SYDNEY WESTERN CITY PLANNING PANEL

ASSESSMENT REPORT

Panel Reference	2019WCI001
DA Number	DA-926/2018
LGA	Liverpool City Council
Proposed Development	<p>Construction of a commercial tower and a new entertainment and leisure precinct (ELP) at the existing Westfield Shopping Centre.</p> <p>Liverpool City Council Is The Consent Authority And The Sydney Western City Planning Panel Has The Function Of Determining The Application.</p>
Street Address	<p>Lot A DP 33536, Lot B DP 33536, Lot 1 DP 34300, Lot 5 DP 36148, Lot 6 DP 36148, Lot D DP 382865, Lot E DP 382865, Lot 12 DP 710597, Lot 13 DP 710597, Lot 14 DP 710597, Cnr Lot 1 DP 729652, Lot 2 DP 729652, Cnr Lot 20 DP 807472, Lot 21 DP 807472, Lot 1 DP 554550, Cnr Lot 21 DP 613438, Cnr Lot 22 DP 613438, Lot 433 DP 822256, Lot 435 DP 822222, Part Lot 1 DP 136327, Lot 11 DP 1068213, Lot 1 DP 958735, Lot 12 DP 1068213, Lot 13 DP 1068213, Lot 14 DP 1068213, Lot 20 DP 871292, Lot 100 DP 1033517, Lot 101 DP 1033517, Lot 100 DP 620292, Lot 423 DP 720737</p> <p>Westfield Shopping Centre, 25 George Street, Bathurst Street, Northumberland Street, 17 Secant Street, Lot 12 – 14 Northumberland Street, Lot 20 Secant Street, Lot 100 Bathurst Street,

Figure 3: Extract of building height from the original architectural drawings (area marked in yellow is part of building that exceeds the building height of 35m).

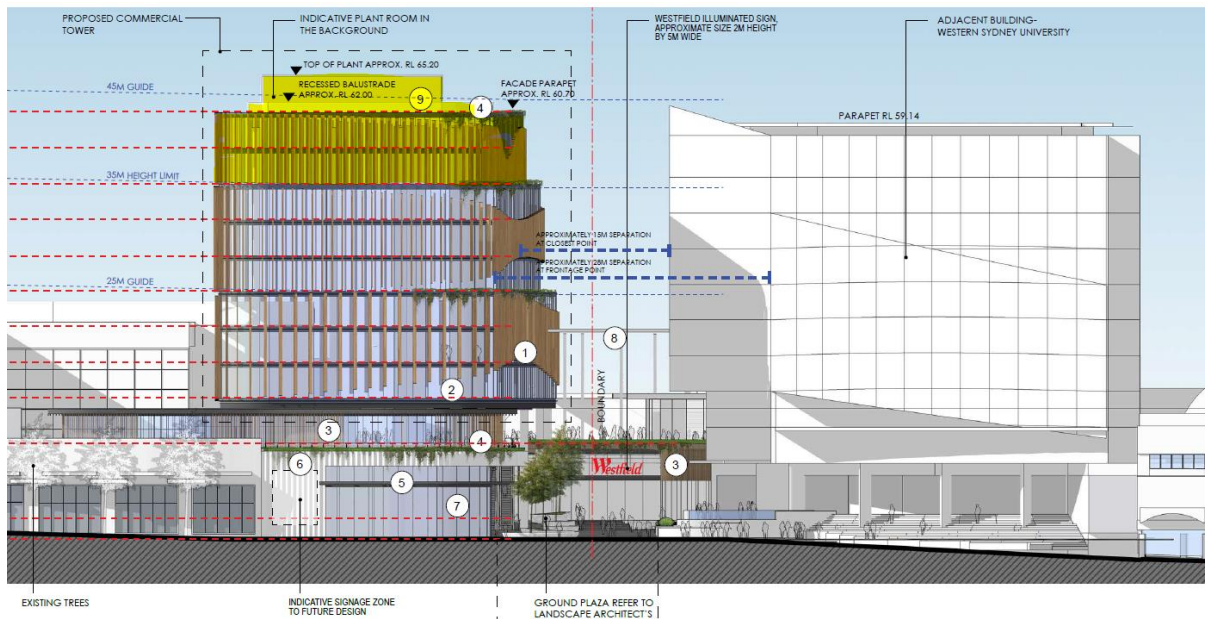
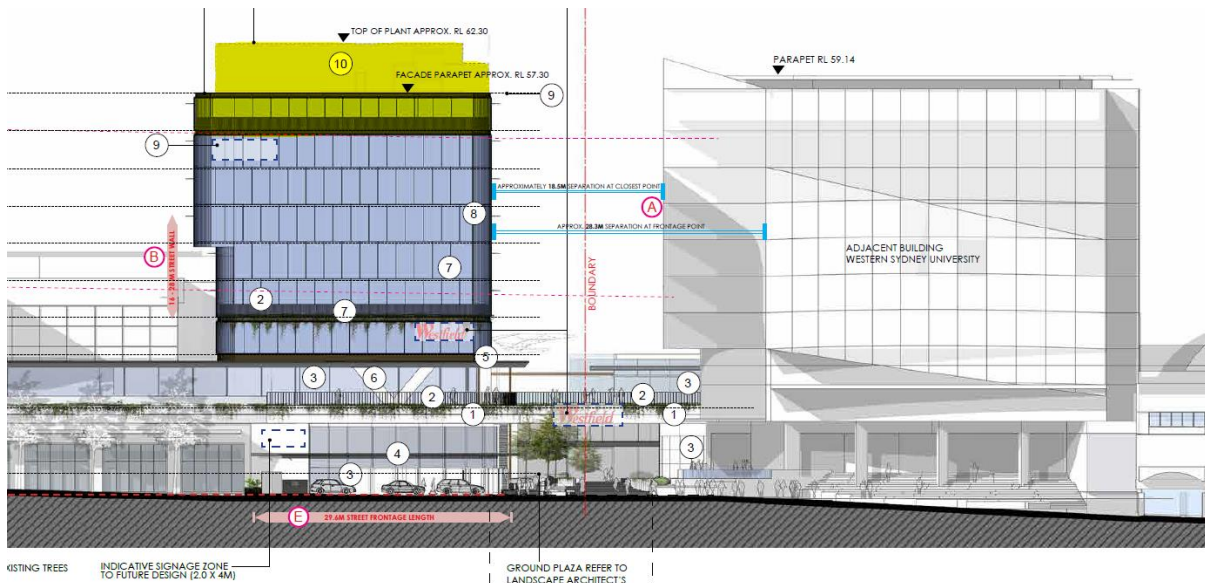
- Significant height exceedance (36%) – justification for seeking cl4.6 variation rather than lodging a planning proposal or site specific DCP.*

The proposed development originally had a height of 47.7m AHD up to the top of plant room on Level 12 of the office tower. This is a variation of 12.7 metres or 36%. The height variation is shown in Figure 3 below.

The proposal has been revised with a reduction in overall building height. The proposed development provides a height of 39.5m to the top of parapet and a height of 44.5m to the top of plant rooms, which equates to 12.8% and 27%, respectively. See Figure 4 below.

Figure 4: Extract of building height from the revised architectural drawings (area marked in yellow is part of building that exceeds the building height of 35m).

Figure 5: Original landscaping proposed in the pedestrian corridor as extracted from the submitted landscape drawings

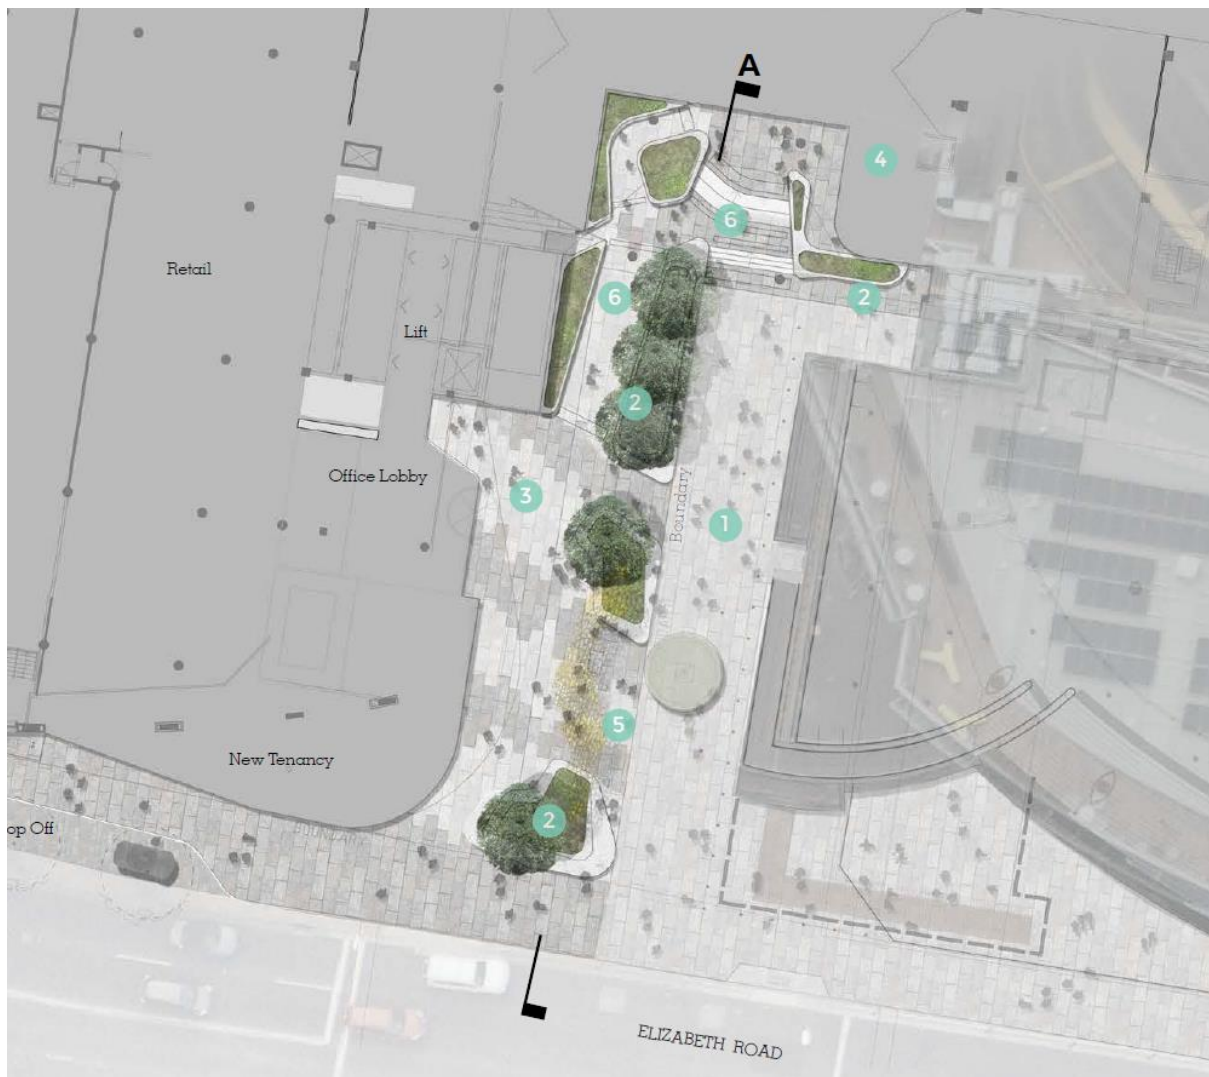
Comment: In its existing form, the mall entry of the shopping centre connects to the public domain both visually and physically via a pedestrian corridor. The existing pedestrian corridor comprises two properties, known as Lot 435 DP 822222 and Lot 8 DP 1217134. It should be noted that Lot 435 belongs to the shopping centre site and Lot 8 belongs to the University site. There are no reciprocal rights of way over the pedestrian corridor.

The development proposes changes to the mall entry of the shopping centre at the Elizabeth Drive frontage, including modifications to the layout and size of the mall entry. The proposal extends the width of the pedestrian corridor further west in order to achieve greater trafficable areas between towers. However landscaping is also proposed in the pedestrian corridor which reduces any increase to useable width and which is considered to divert the majority of pedestrian traffic onto the UWS site, into the shopping centre.

Notwithstanding this, it is recognised that the planters play a function in providing green amenity as well as providing rest space within the pedestrian corridor. Council does not oppose tree planting and seating in the pedestrian corridor provided it is suitable in scale and location. Also, any tree planting and seating would need to be designed such that it is consistent with recent public domain improvements i.e. the same tree species and bench-type seating as the mall.

In response, the applicant submitted a revised concept that provides for tree planting within the corridor with an integrated public bench encircling the tree. The revised design also increases the amount of area in the corridor to retain and enhance existing paths of travel for pedestrians. The applicant has submitted a letter from a BCA consultant to confirm that sufficient width is available in the pedestrian corridor for path of travel to Elizabeth Drive. The proposed development does not pass over the adjoining allotment.

Figure 9 – Extract of the submitted plans showing the building elements which exceed the height limit.

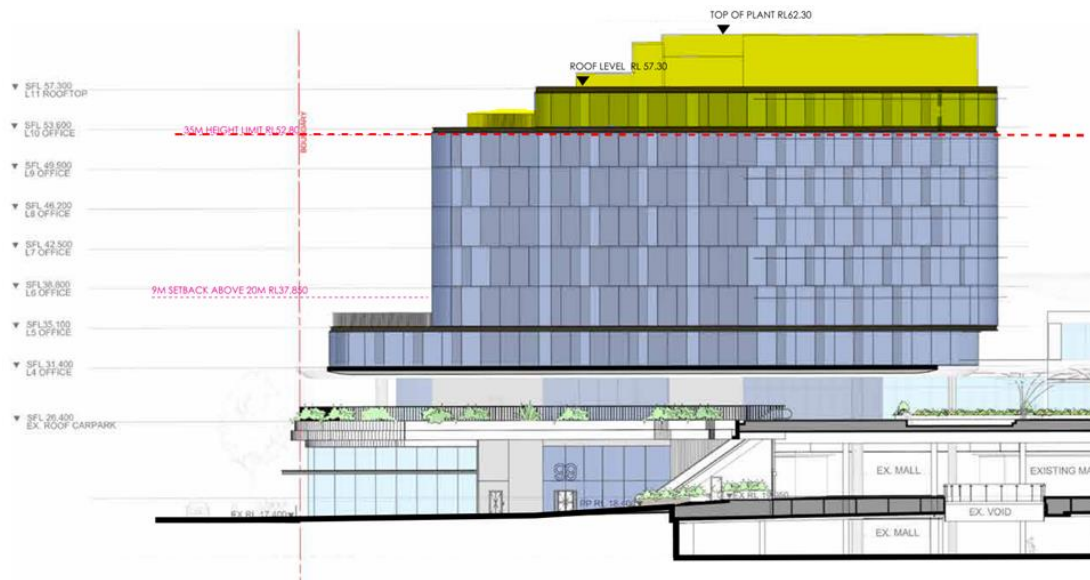
As identified in the compliance table above, building height does not comply with the provisions of the LLEP 2008. Clause 4.3(2) of the LLEP 2008 identifies a maximum height of 35m for the site. The development proposes a height of 39.5m to the top of parapet and a height of 44.5m to the top of plant rooms.

The non-compliant height is shown yellow in the below figure.

Consequently, the applicant has provided a clause 4.6 variation to justify the non-compliance.
